WORK ORDER NON-CONFORMANCE / UPDATE

D3394-041/-043 LUG ASSEMBLY

DRAWING NO.	D3394	TITLE	REV. B	DART AEROSPACE LTD ENGINEERING ORDER	D.E.O. NO.	D3394-B-1	SHEET NO.	SHEET 1 OF 1	SCALE
DRAWN	AJS	CHECKED	MFG. APPR.	APPROVED	DE APPR.	DATE	09/11/04	DATE	09/11/04

DRAWING NO. D3394	TITLE LUG	REV. B	DART AEROSPACE USA, INC ENGINEERING ORDER		D.E.O. NO. D3394-B-2	SHEET NO. SHEET 1 OF 1	SCALE NTS
DRAWN 92	CHECKED SC	MFG. APPR. M	APPROVED MP		DE APPR. H		
DATE 11.05.02	DATE 11.05.09	DATE 11.05.09	DATE 11.05.09		DATE 11.05.09

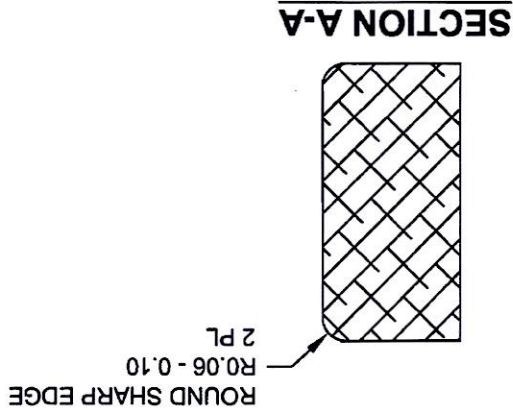
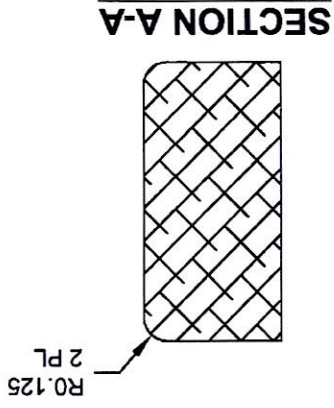
SHEET 4 ZONE A, 1 MODIFY SECTION A-A AS SHOWN:

IS:

WAS:

REASON: DRAFTING ERROR

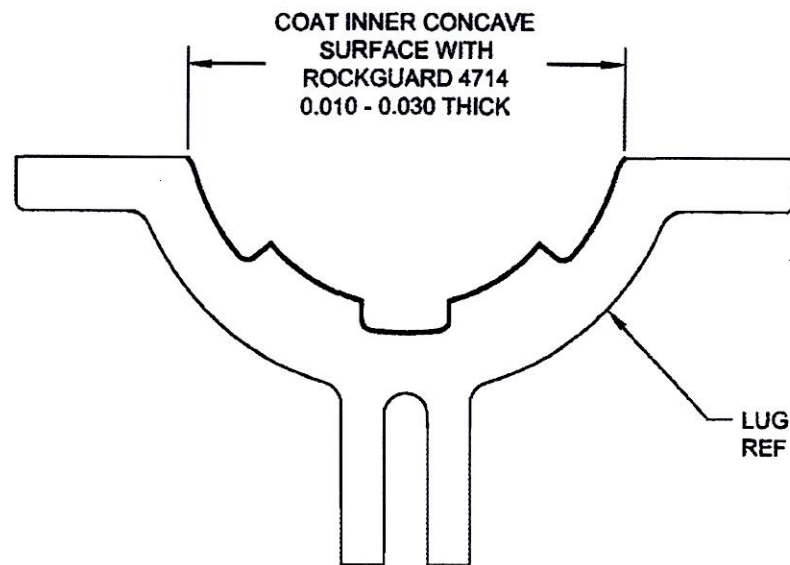
ADD D3394-xRG OPTION

D3394-xRG MOUNTING LUGS ARE INDENTICAL TO D3394-x MOUNTING LUGS, HOWEVER AFTER FINISH, COAT INNER CONCAVE SURFACE WITH "PLUS ONE ROCKGUARD 4714" AS SHOWN BELOW.

D3394-1RG LUG (SHOWN)
D3394-3RG/-5RG LUGS (SIMILAR)
D3394-041RG/-043RG/-045RG LUG ASSEMBLIES (SIMILAR)
